Proposed Site Plan

P404_ 128 Old Lansdowne Road

Client: Rebecca Nichols
Drawing Number: **P404_108**
Drawing Title: **Proposed Site Plan**
Date: 24/04/2025
Scale: 1:200 @ A4

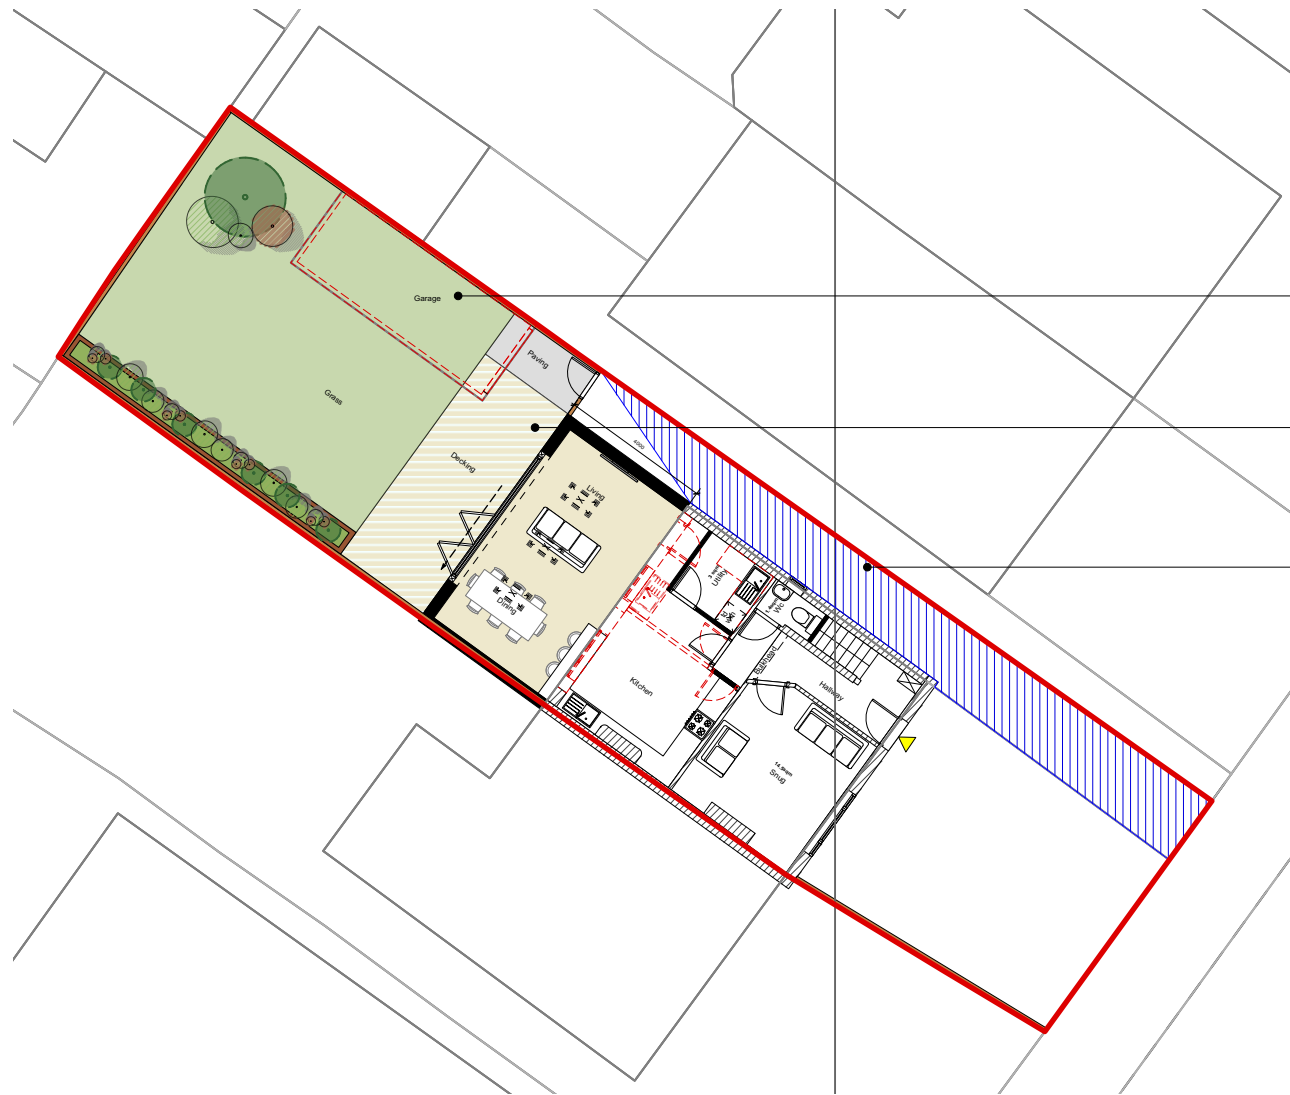
A 05/09/2025 Drawing status updated to Planning. Extension depth reduced to 4m in response to planner's comments dated 02.09.2025.
